**UPPER UWCHLAN TOWNSHIP
PLANNING COMMISSION
AGENDA
February 13, 2020
7:00 p.m.**

Reference: Vantage Point Retirement Living (Parcel 6C)
Final PRD Plan – First Review
Upper Uwchlan Township, Chester County, PA

Re: Vantage Point Retirement Living (Parcel 6C)
Final PRD Plan – First Review
Upper Uwchlan Township, Chester County, PA

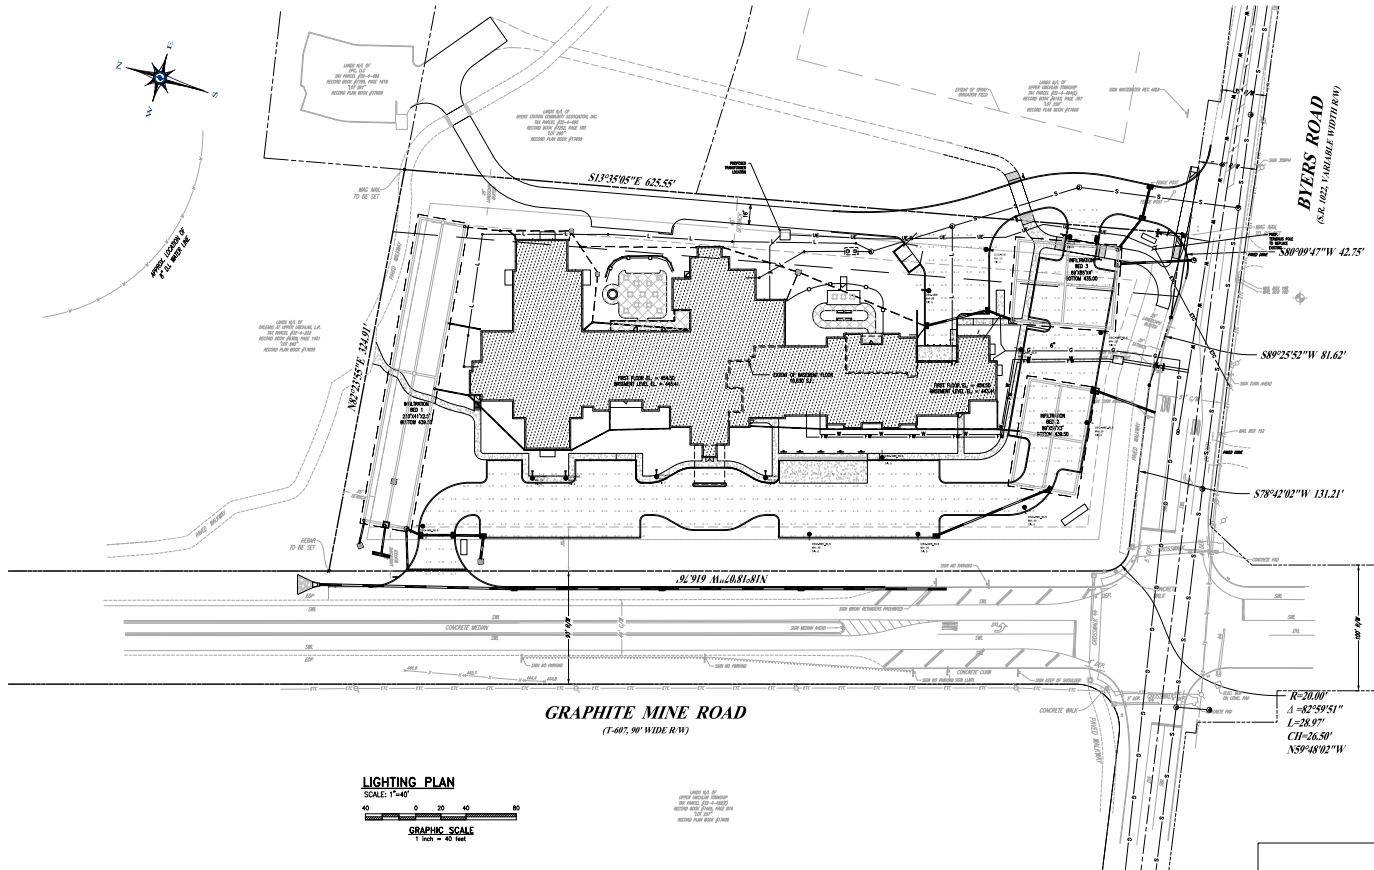
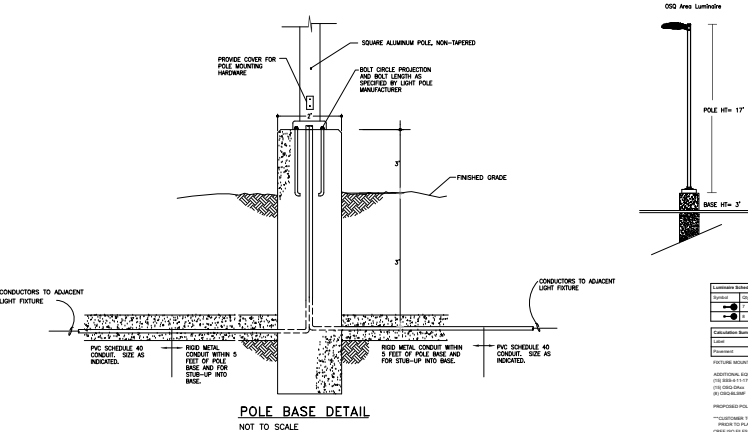
Sheet 16, Lighting Plan, Rev. 4, dtd. 12/06/19, for the Byers Station 6C, Lot 6, Vantage Point Retirement Living Parcel Land Development has been received and reviewed. The following concern and recommendation, based on the lighting requirements contained in SLDO §614, Lighting, and reasonable customary engineering practices, is offered for Township consideration.

According to the revised Luminaire Schedule, all proposed site lighting has been revised from the previously specified 5700K LED luminaires to 3000K LED sources. However, the plotted illuminance levels continue to be as plotted on the Rev. 3 5000K version. Manufacturer's photometric data indicates that when going from 5000K to 3000K sources, there should be a measurable drop in light output, but the most recent lighting layout does not reflect any such reduction in plotted footcandle levels.

It is recommended Applicant be requested to review this apparent anomaly and to take appropriate corrective action, and to include on Sheet 16 the names of the .ies photometric files that were used to generate the plotted illuminance values.

The lighting plan has been revised to use a 3000K color light instead of the previously proposed 5700K. A revised lighting plan has been submitted for review and approval.
